Sheet: /
File: Project_OAK_MAIN_BRD_V0.1.sch

Title: Project OAK MAIN BRD V0.1

LED MATRIX CONTROL SECTION

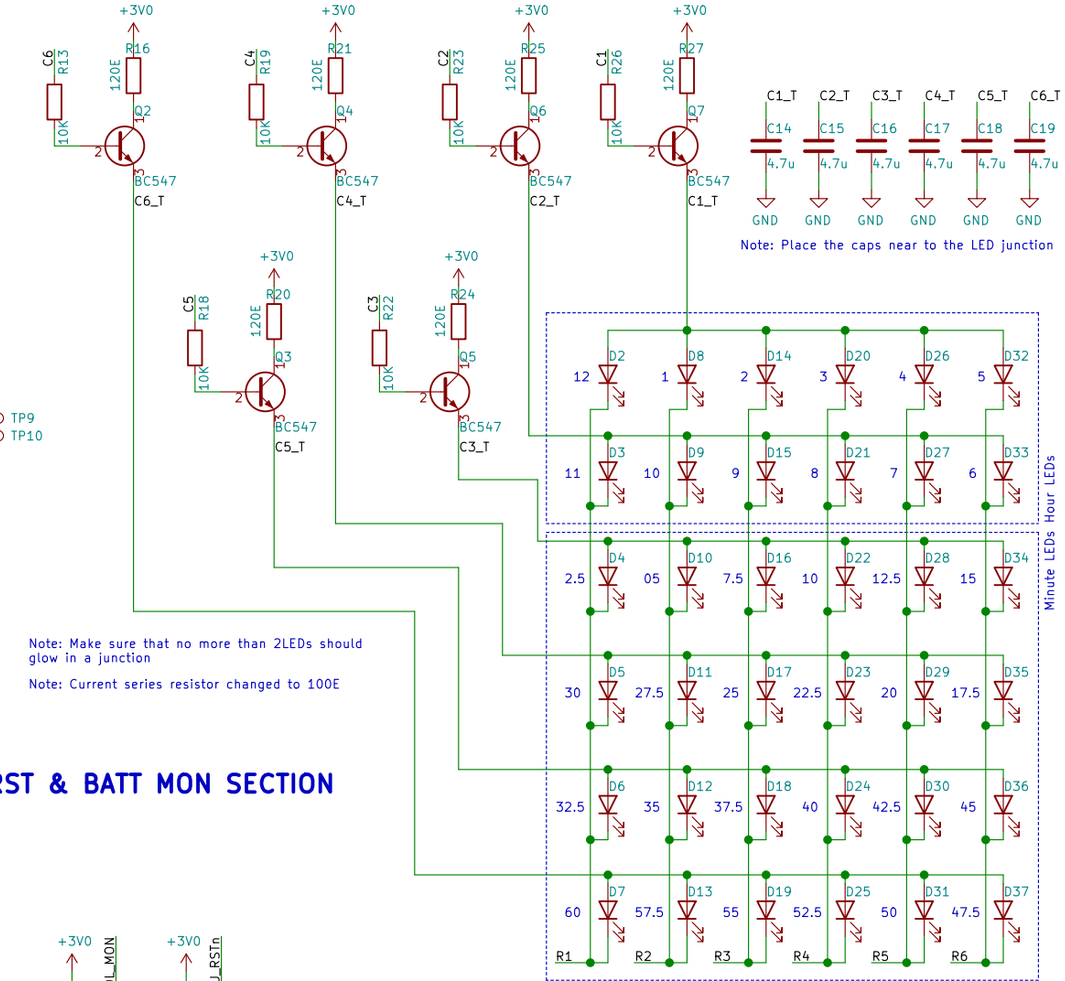
Transistor symbol need to be changed to SOT23 type

Note: Place the caps near to the LED junction

Note: Make sure that no more than 2LEDs should glow in a junction

Note: Current series resistor changed to 100E
